TWEED
SHIRE COUNCIL

Agenda

Planning Committee Meeting Thursday 7 September 2017

ITEM	PRECIS	PAGE
	REPORTS THROUGH THE GENERAL MANAGER	6
	REPORTS FROM THE DIRECTOR PLANNING AND REGULATION	6
1	[PR-PC] Development Application DA16/0178 for the Use of Illegal Additions to Two Existing Dwellings and Shed at Lot 2 DP 348945 No. 54 Phillip Street, Chinderah	6
2	[PR-PC] Development Application DA17/0084 for a Seniors Living (33 Aged Care Residential Rooms and 36 Independent Living Units) at Lots 1, 3 & 4 NPP 271020 Nos. 124-128 Leisure Drive, Banora Point	41
3	[PR-PC] Development Application DA17/0102 for a 17 Lot Community Title Subdivision (16 Residential Lots and 1 Community Lot) at Lot 156 DP 628026 No. 40 Creek Street, Hastings Point	130
4	[PR-PC] Development Application DA16/0795 for a Two Lot Subdivision and Dwelling at Lot 7 DP 1178620 No. 2041 Kyogle Road, Terragon	148
5	[PR-PC] Development Application DA04/0162.03 for an Amendment to Development Consent DA04/0162 for Expansion and Amalgamation of Existing Quarries at Lot 28 DP 1079480 Pollards Road, Dulguigan	189

SITE PLAN & SITE ANALYSIS SCALE 1:400

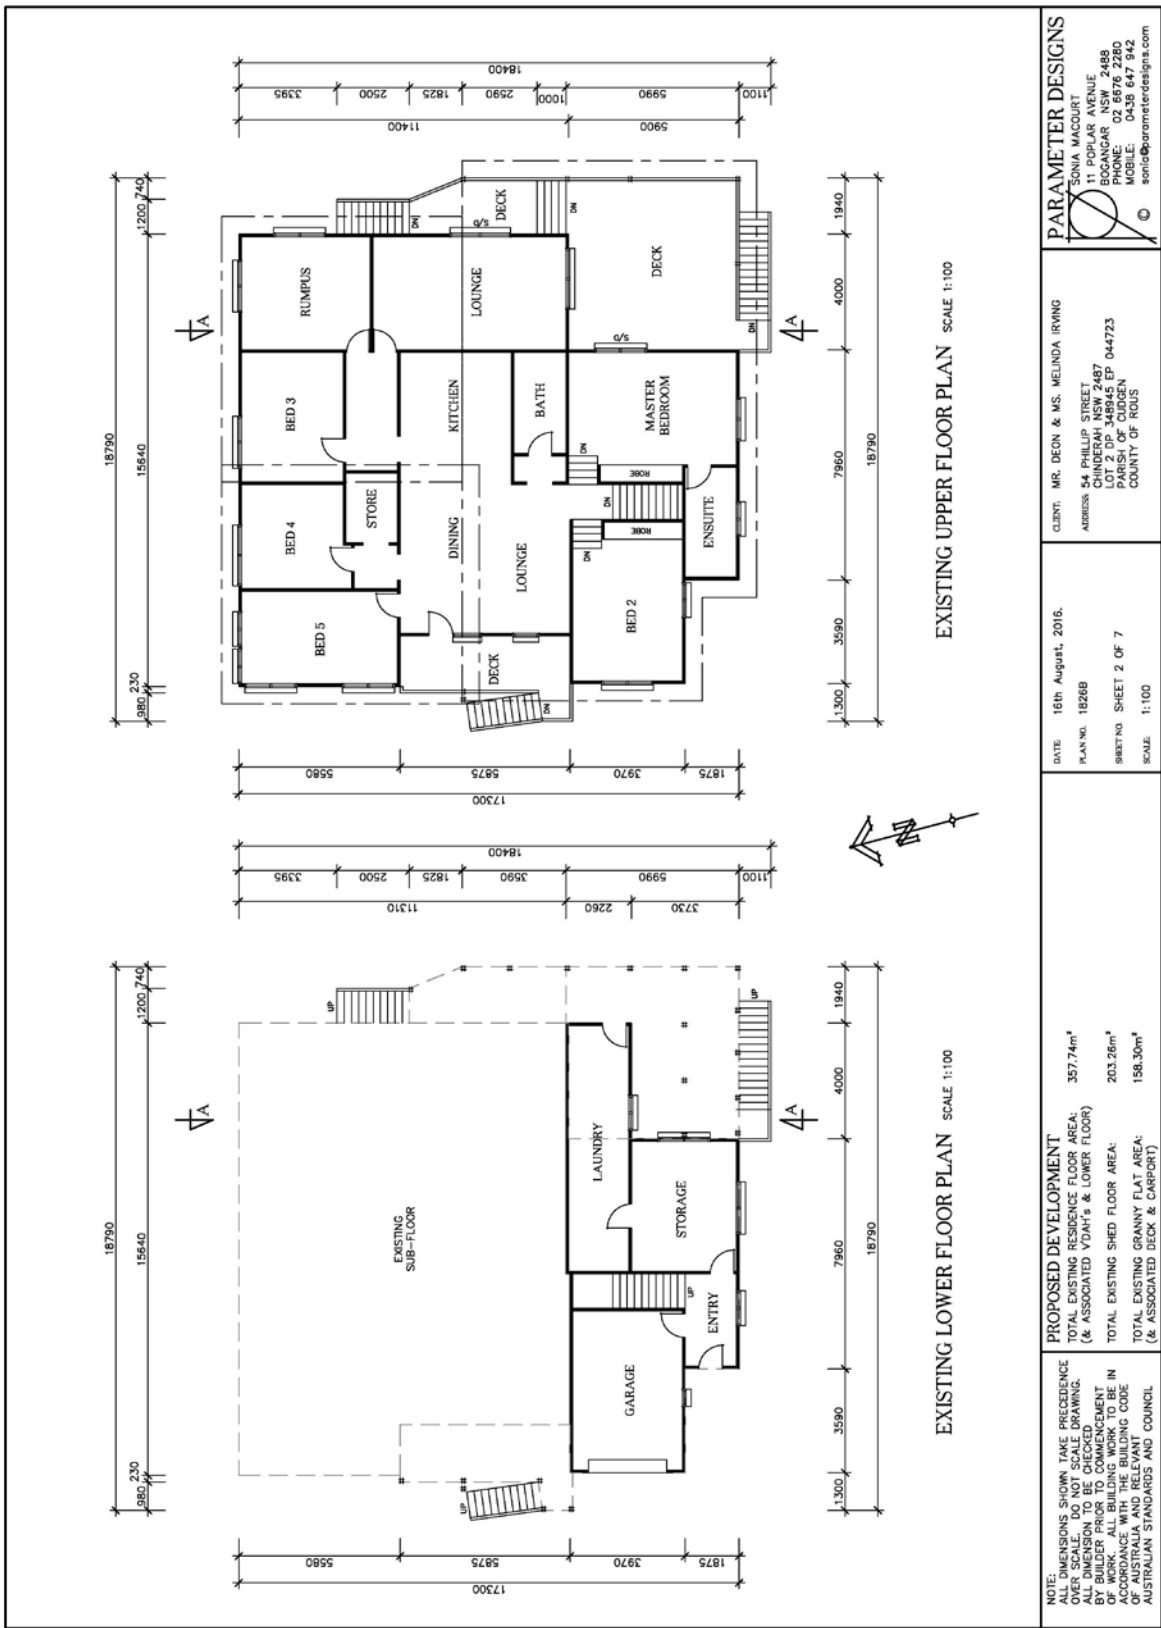
On that basis it is important to mitigate the impact of flooding on existing and future occupants of both these structures. Based on the plans provided, the lower level of House 1 and House 2 do not meet the minimum habitable floor level requirements by 0.8m – 1m.

Generally only minor extension/expansion of existing dwellings are permitted which is limited to 35m² of the original structure as defined by Section A3 of TDCP 2008. In this instance the original structure of House 2 has more than doubled in size with approximately 80m² being added to the structure without the required approvals. Council's Flooding Engineer recommended two bedrooms be removed from the floor plan of House 2 (as outlined below) or alternatively the existing structure can be raised to the minimum habitable floor level of RL 3.6m AHD to comply.

- House 1 - That the store room adjacent the laundry shall not be converted to a habitable space given it is well below (1m) the Design Flood Level.*
- House 2 - That a minor extension/expansion of the original structure is permissible for approximately 35m². In this instance the two bedrooms shall be removed from the floor plan on the Parameter Designs documentation. Alternatively the existing structure can be raised to the minimum habitable floor level of RL 3.6m AHD to comply with the DCP.*

Figure 2 Adjusted development boundary identified for possible consideration, subject to the applicant identifying a lot layout and development footprint that can be wholly contained within and satisfactorily addressing all other issues identified herein.

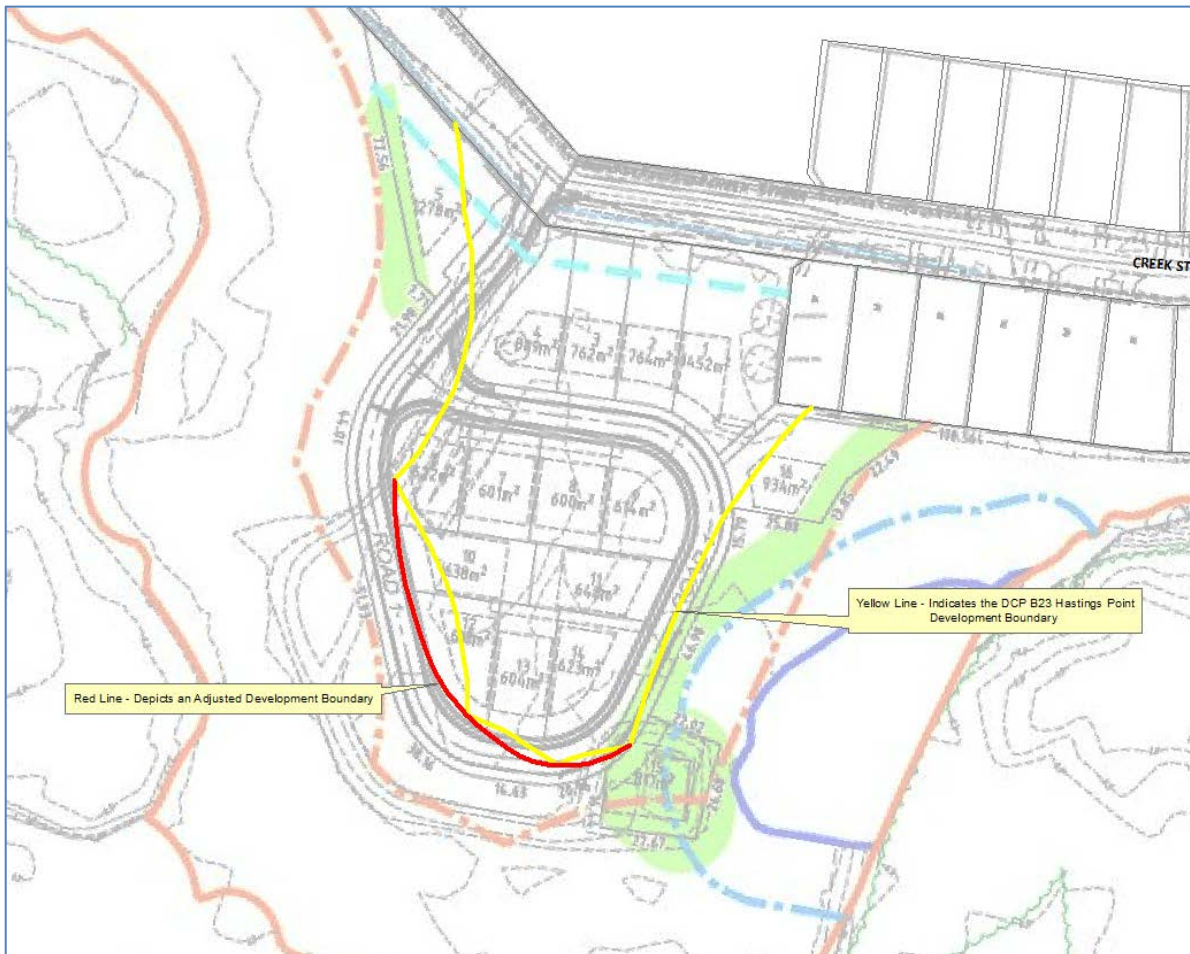
With respect to the Tweed DCP B23 ecological buffer provisions, it is clear from Figure 1 above that the proposed development fails to comply with the applied 75m Saltmarsh buffer prescribed within DCP B23. The difficulty of achieving best practice development design becomes apparent in the irregularity of the resulting development footprint. Such an irregularity may limit development layout options to accommodate a perimeter road due to the geometry of the DCP B23 development boundary. In order to achieve an acceptable ecological setback whilst enabling a practical and desired best practice lot layout, the merit of adjusting the development boundary to suit may be (as an example) a design element that could be the focus of negotiation.

As demonstrated in Figure 2 below, the deletion of Lots 1-5 and 16 to resolve engineering issues would also result in the 75m Saltmarsh buffer generally being met for new residential lots, if utilising the red line provided below. While the 75m Saltmarsh buffer footprint, nominated within Tweed DCP Chapter B23, requires all development to be outside the 75m buffer, indicated by the yellow line, the footprint nominated illustrates that only services and an internal road will be within this footprint.
